7-ELEVEN #38106

MASTER PLAN

Addendum—3/17/2017

CANOPY & OPEN PERGOLA ELEVATIONS

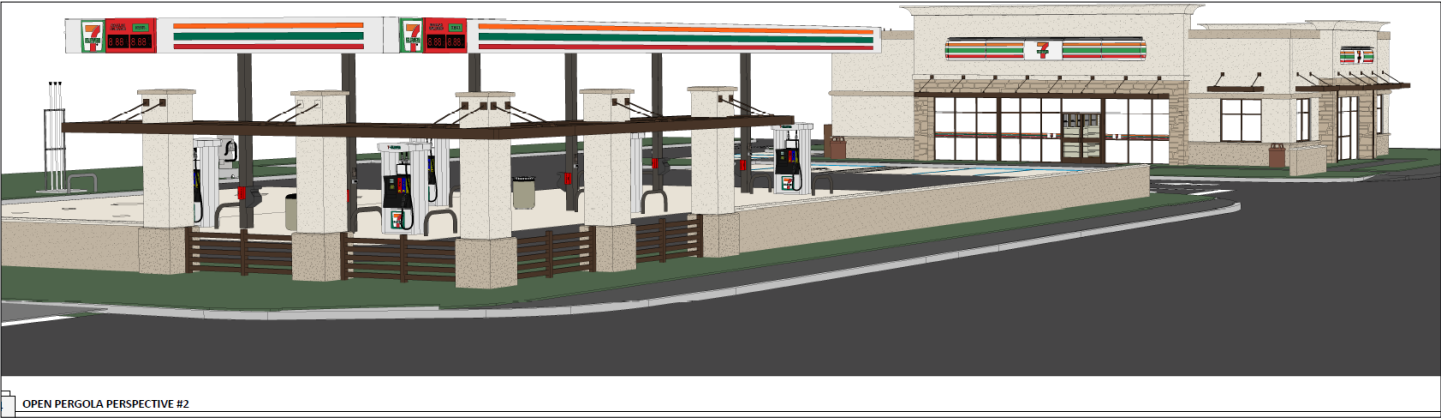
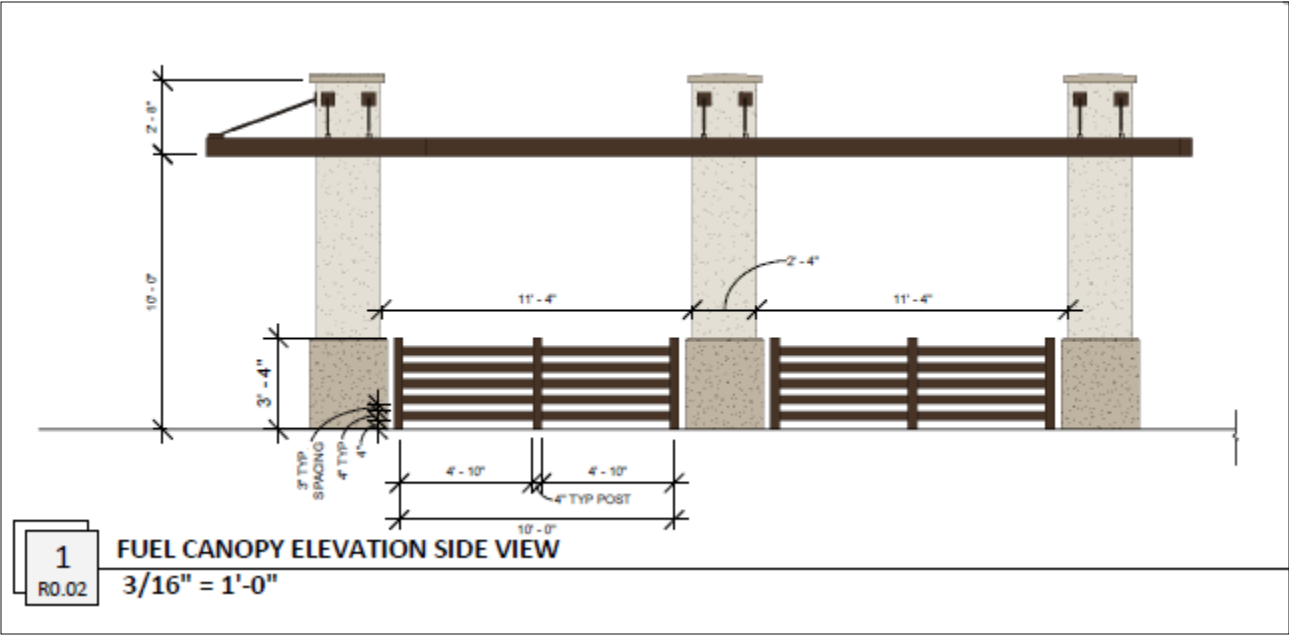
Page 5—Updated renderings of pergola
